247 (GLA/GLB) with 235 & 501 - Rearview Camera Noise Optimization

Topic number	LI54.71-P-080349
Version	1
Function group	54.71 - Camera and radar-assisted assistance systems
Date	3/25/26
Validity	247 (GLA & GLB) with all of the following: <ul style="list-style-type: none">- Model Year 2024 and later (Option code 804, 805, 806, etc...)- Option code 459 or 485 (Steel spring variants)- Option code 235 AND 501 (PARKTRONIC with Active Parking Assist)
Reason for change

View PRIOR to SCN Coding:

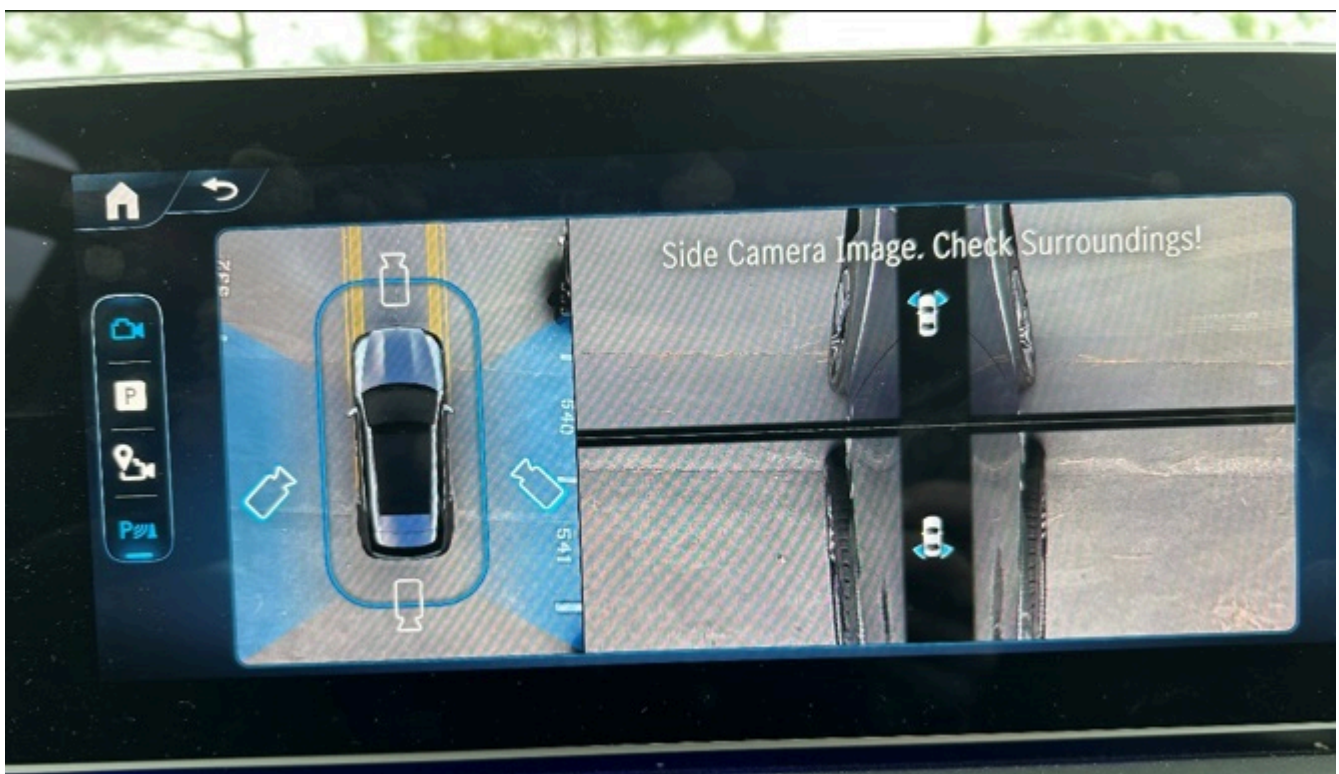
IMPORTANT: After both control units have been SCN coded, the "Movable 3D View" feature in the head unit will no longer be available. With this change there will be two distinct differences:

- 1) The "3D" icon when in the top down vehicle view, will no longer be present on the head unit.
- 2) The digital rendering of the vehicle with the ability to spatially move around the vehicle is no longer possible. This view is replaced with 2D static images of the left and right sides.

- Rear camera flap when calibrating after a key cycle bus sleep will stay open to 29 MPH and then close. Will re-open, when calibrating, at 9 MPH.
- The head unit screens mentioned above appear the same as "View AFTER SCN Coding" as shown in the attachment.
